CNC Controller schematic Issues List

CNC Controller 4-axis schematic

CNC Controller schematic (one axis shown)

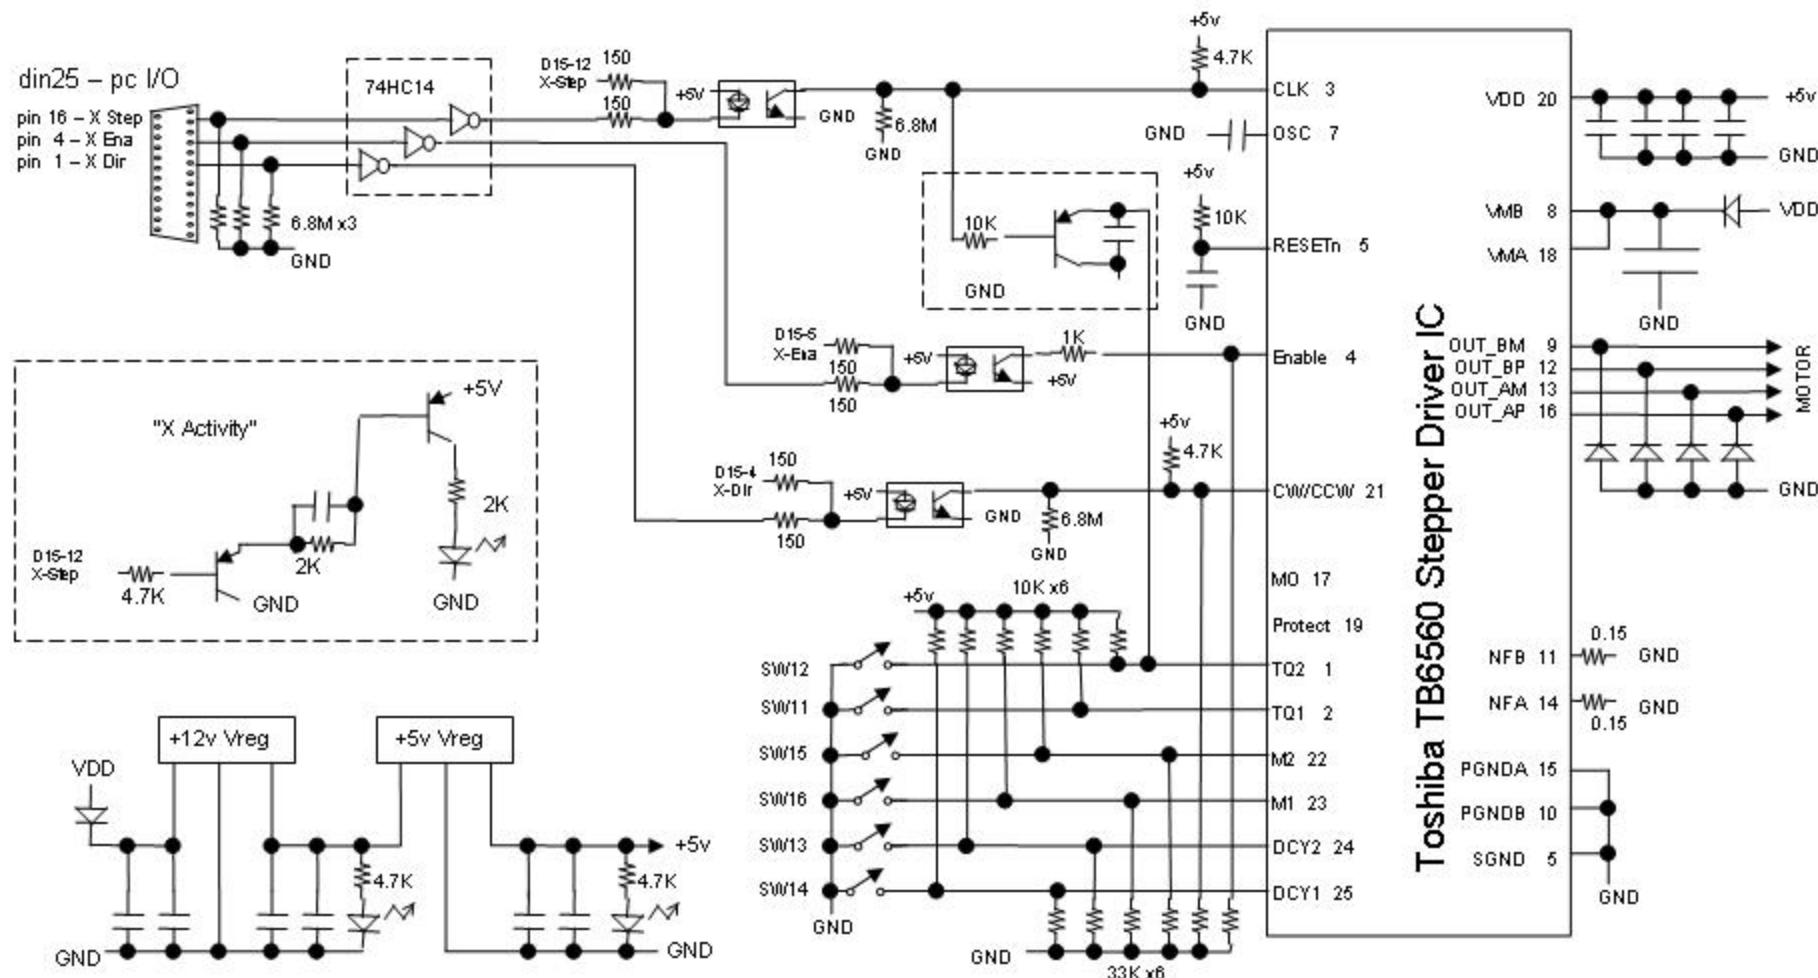
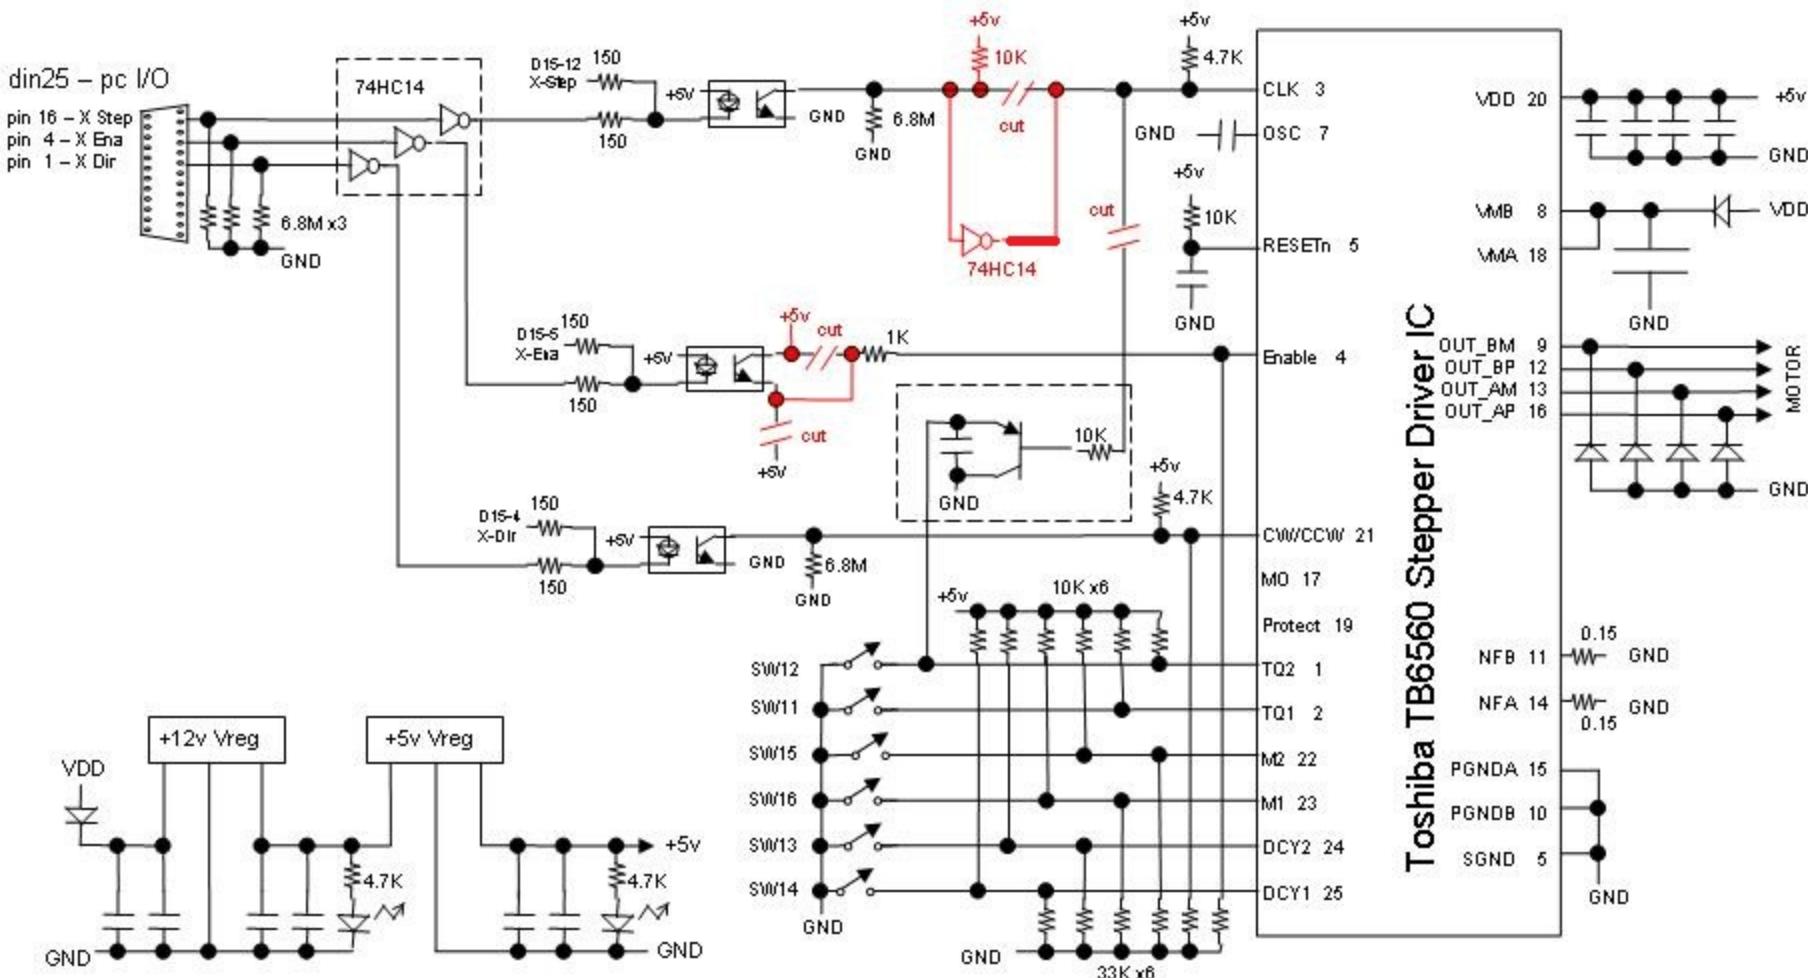
- 1) Driver IC CLOCK input improperly driven: The TB6560 uses the rising edge of the CLOCK input (not explicitly called out in IC spec except for "rising edge" symbol shown in one table). The slow turn off time of the opto-coupler combined with the passive pull-up resistor are insufficient and allow system noise to cause unstable driver circuit operation. Solution: Actively drive the CLOCK input using added 74HC14 IC as buffer.

- 1) Driver IC ENABLE input improperly driven: The opto-coupler for the ENABLE input is wired incorrectly having the npn emitter connected to supply. Although the circuit does function, the improper wiring of the npn will cause very low transistor gain opening the possibility of system noise corrupting the ENABLE signal. Solution: Rewire the npn of the opto-coupler with collector to supply and emitter to output.

- 1) Activity LED improper function: The activity LED circuit works properly when the STEP signal from the PC has high duty cycle (active low orientation). However, the TB6560 spec directly states that proper operation requires low CLOCK (e.g., STEP) signal duty cycle (or active high orientation). With active high orientation signal the activity LED remains lit even when the driver is not being 'stepped'. Solution: None.

- 1) Potential for Overheating of 12V Voltage Regulator: The cooling fan is fed directly from the 12V Vreg output adding significantly to the loading of the device. The 12V Vreg will shut down if it overheats protecting itself; such a shutdown would result in lost steps of an active motor. Solution: Power the cooling fan with an external supply or (with suitable step down circuit) from the stepper motor supply voltage directly.

- 1) System Not Optically Isolated: Despite having opto-couplers on all PC inputs and output, the controller does not properly implement optical isolation of the PC from the driver IC's nor from the stepper motor power supply. This is due to sharing of ground among all circuits. Solution: Assure PC and stepper motor power supply externally share the same earth ground.

- 1) Drive Current Manipulated by CLOCK/STEP signal: It appears that an attempt was made to implement a feature where the driver would reduce current to the stepper motors when the motors were idle. This was accomplished by pulling the drive current set input low when the CLOCK signal was active. And although the feature does work for current settings of 25% and 50%, the implementation has negative side effects that outweigh the feature usefulness:

- the feature departs from the reference design of the TB6560 reference spec resulting in the spec no longer accurately describing operation
 - motors may be overdriven with higher than programmed drive current

- artificially raises the lowest current motor that the controller board can safely driveSolution: Disconnect the non-spec circuit.
- 1) Operating Voltage Mis-information: The board is marked for input voltage "12v to 36v" but the IC spec indicates maximum operating voltage of 34V. But even that is probably not a safe operating point due to potential stepper motor generated voltage spikes. The controller board output diodes will clamp large overvoltage spikes when the diode breakdown voltage is reached, but the breakdown voltage is likely above the maximum voltage the driver IC can sustain without damage. Solution: Recommend limiting input voltage to 30v or less to provide margin of safety for operation.
